EB-PU2113W PU2116W/PU2120W

PU2213B/PU2216B/PU2220B

Firmware Release Notes

7/21/2025

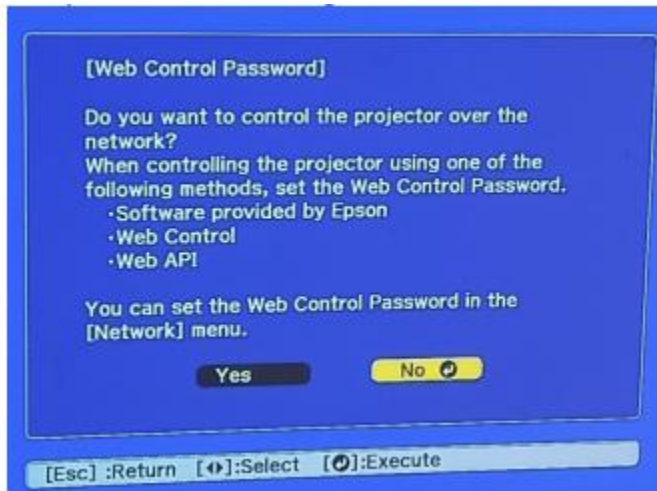
3) Specification change to the following password settings:

3-1. Monitor password ▪ Added a setting item for "Monitor Password" to the menu. [Network settings] -> [Basic] -> [Monitor Password] ▪ If the following condition, display the dialog to set the Monitor Password - Monitor Password: have not set - Command Communication set to "Compatible"

3-2. Web control password If the following condition, display the dialog to promote setting the Web Control Password - Web Control Password: have not been set - Complete network settings

[Yes]: Move to set the Web Control Password

[No]: Complete the network settings with no set Web Control Password

"Extended" > "Multi-Projection" > "Simple Blending"

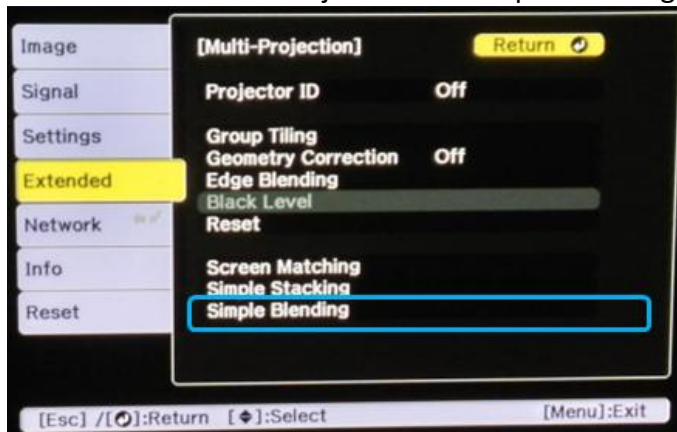
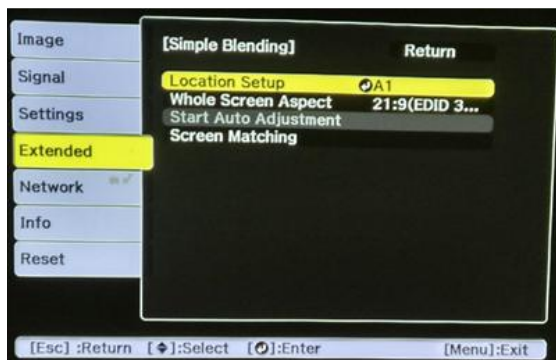
- 1) A new function of "Simple Blending"* is available
- * This function can be blended by connecting wired LAN between two projectors
- Settings location

- Location Setup: Set the location of the primary projector
- Whole Screen Aspect: Set the aspect ratio after blending
- Start Auto Adjustment: Display is adjusted automatically using an external camera.
- Screen Matching: Each display's color and brightness are corrected.

<After>

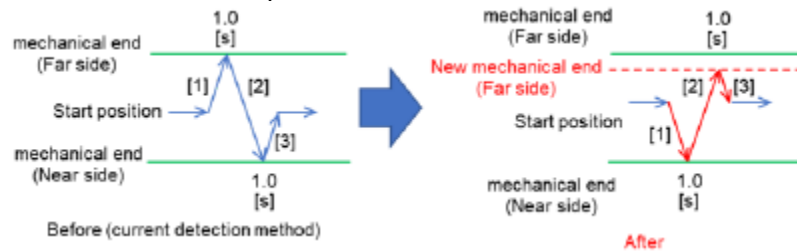
- 1) Changed detection method for distortion lens operating range during lens calibration.
Fixed the distortion error that may occur when ELPLX02/ELPLX02S is installed.

<Before (current detection method)>

- [1] The lens group (A) moves towards the far-side mechanical end
- [2] The lens group (A) moves towards the near-side mechanical end
- [3] Back to the start position.

- [1] The lens group (A) moves towards the "near side mechanical end"

[2] The lens group (A) moves towards the far-side mechanical end. It stops at "New mechanical end**"

set by software

*Position of the "New mechanical end" is located right before the far-side mechanical end

[3] Back to the start position.

*1 The following message is displayed when unsupported lenses are attached.

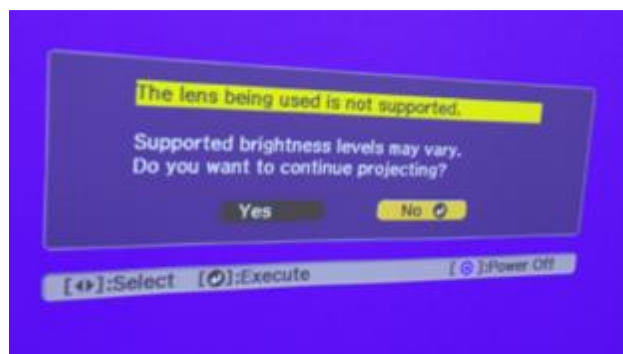
2) Change the specifications of non-supported lens "ELPLU03,ELPLW05,ELPLM08,ELPLM09" to a supported lens.

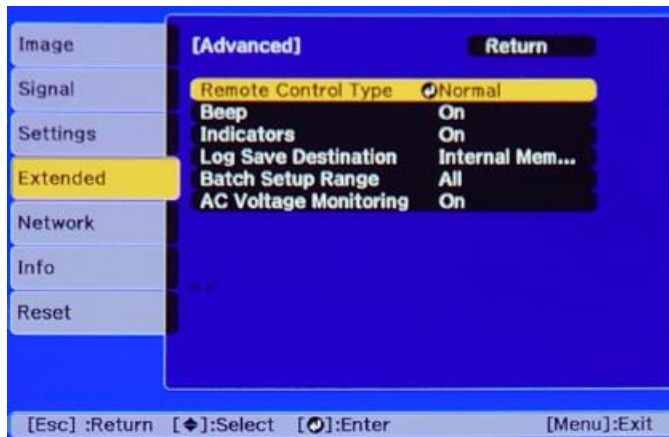
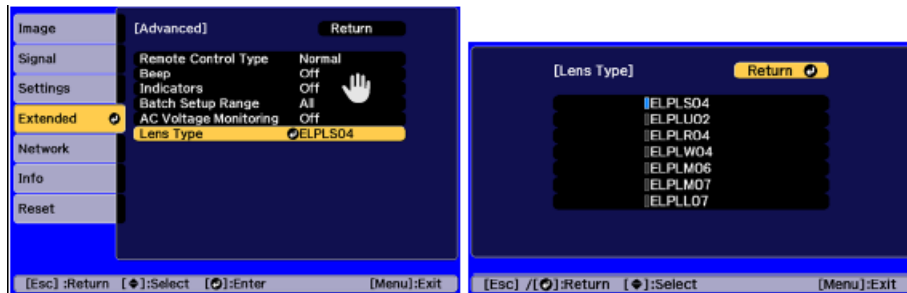
-Fixed bug where unsupported lenses could be selected in the OSD menu. The lens type item and selection menu have been deleted.
